**GEOTECHNICAL EVALUATION & SITE SURVEY  
SUPERINTENDENT'S RESIDENCE  
SAULT CANAL, SAULT STE. MARIE, ONTARIO  
YOUR FILE NO. 6553-0035-52129**

**Project: SO6430G  
Date: January 13, 1995**

January 12, 1995

PHOTOGRAPH #5 & #6

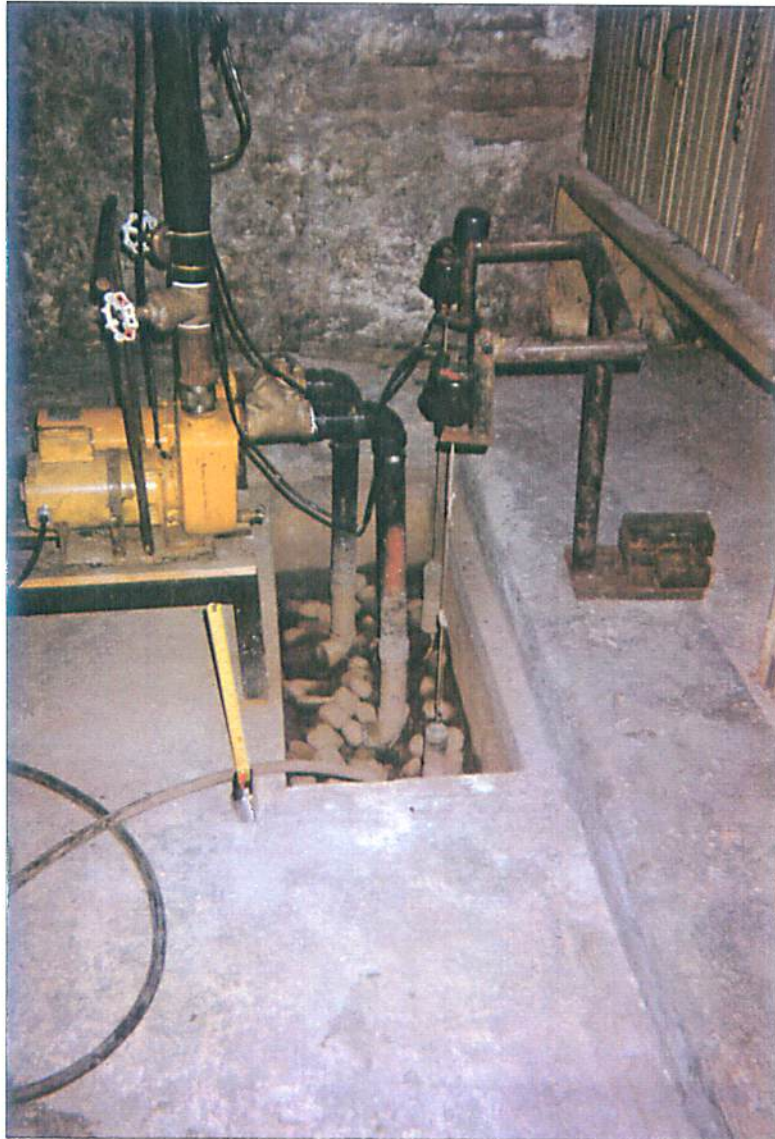
The basement walls are constructed of mortared sandstone, probably parged with cement. The floor is poured concrete slab on grade, with two sump pits. It was noted in the past that water was entering the basement predominantly from the sumps, not from the walls or through the floor. Presently the building is unoccupied. However, it is intended that the building will be occupied in the near future.

Based on our general knowledge of the area and the results of our investigation it is evident, that the water entering into the basement through the sumps is related to the occasional rise of groundwater level mainly from SEICHE effects. In order to curtail the problem it would be necessary to install perimeter and underfloor weeping tile systems around the building and beneath the floor slabs. Such an extensive and costly procedure may, however, be prohibitive in comparison to the assumption that occasional water entering into the basement may be acceptable. It may be more suitable to construct a higher "table" floor in the basement, i.e. above the highest water level at least to the furnace and other facilities.

**PHOTOGRAPH #15 & #16**

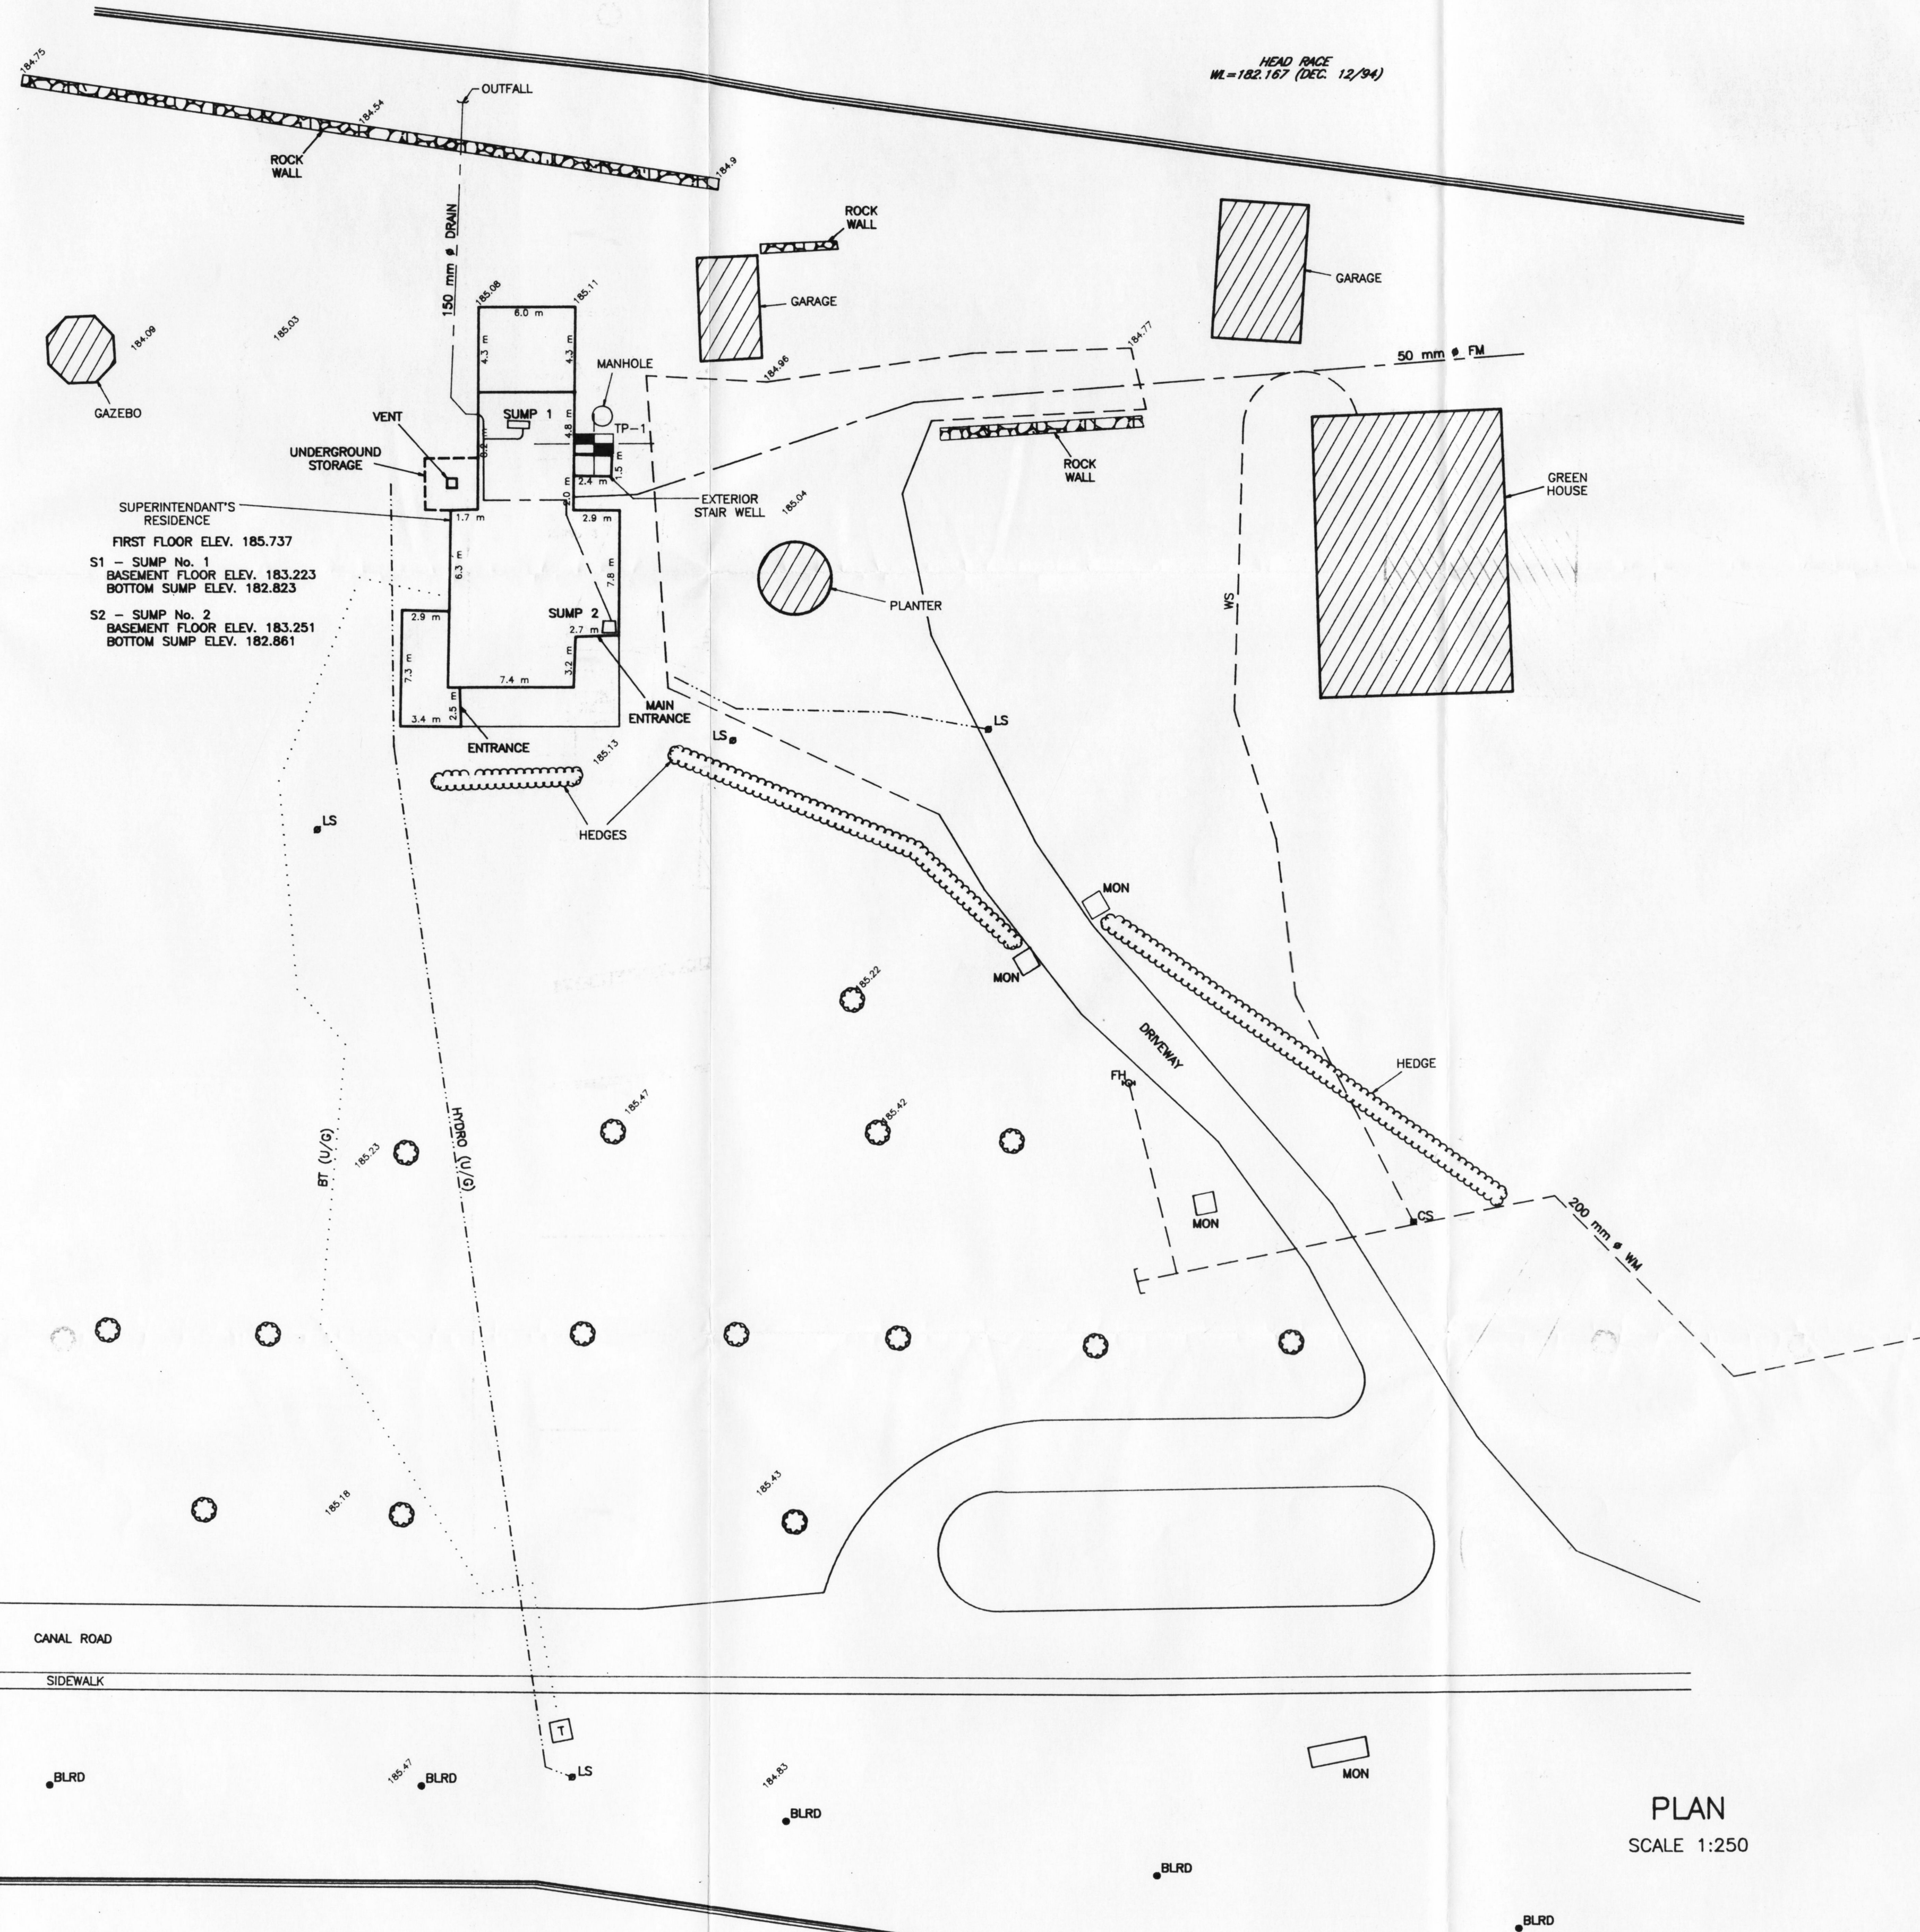
As is visible on photographs 15 and 16, the water level in the canal may rise approximately 0.5 m above the recently noted elevation. With the higher water level there may be an estimated 0.2 m of water in the basement, which coincides with the reported sporadic water seepage problems.

**Trow**  
 GEOTECHNICAL EVALUATION

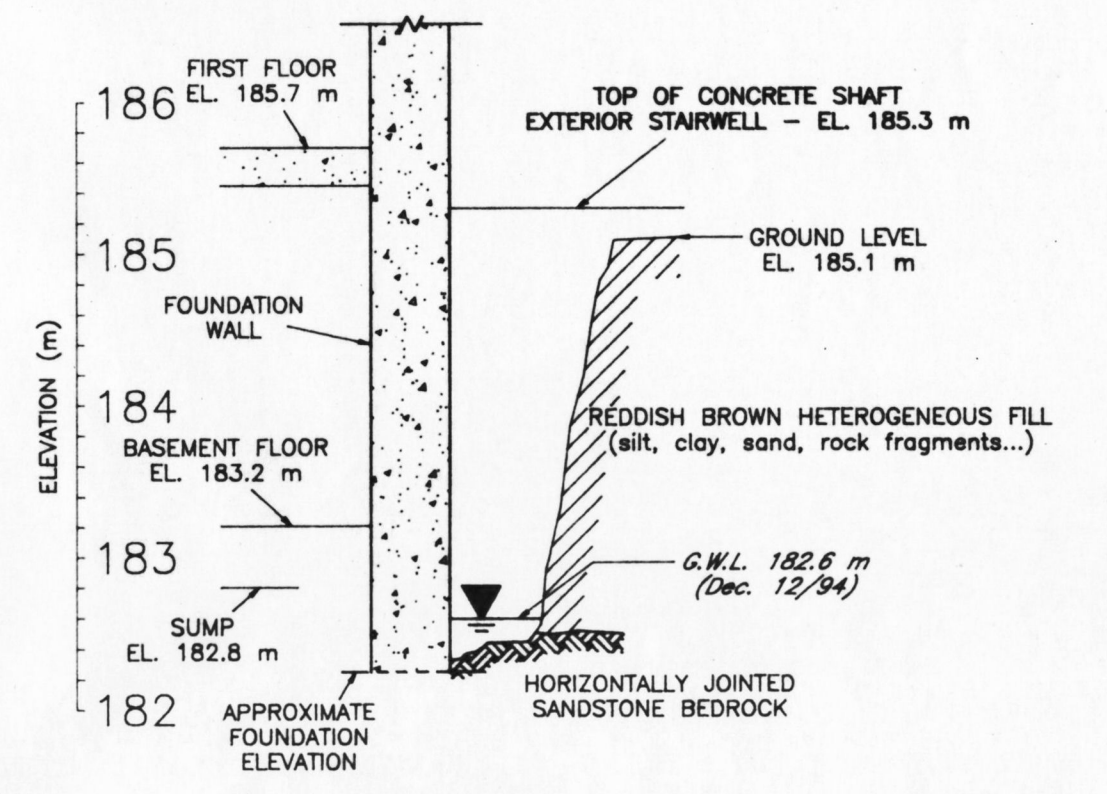
As requested, a detailed site survey was completed in the vicinity of the superintendent's residence, in order to identify the location of the building and all connecting services on the property. The surveying comprised the measurement of horizontal lengths and distances of the building and other objects on the property as well as pertinent geodetic elevations (water, ground, floors etc.) in the area. The results of this study is shown on the attached site plan, Drawing 1.

Because of the presence of numerous buried service pipes and cables around the building, we could excavate only one test pit, near the north-east corner of the residence, immediately adjacent to an exterior stairwell (see Drawing 1, and Photographs 11 to 14). The test pit was excavated using a rubber tired backhoe. The sloughing soil (bouldery fill) and an adjacent manhole made the digging extremely difficult. Nevertheless, the excavation extended to approximately 2.7 m below grade, 0.8 m below basement level.
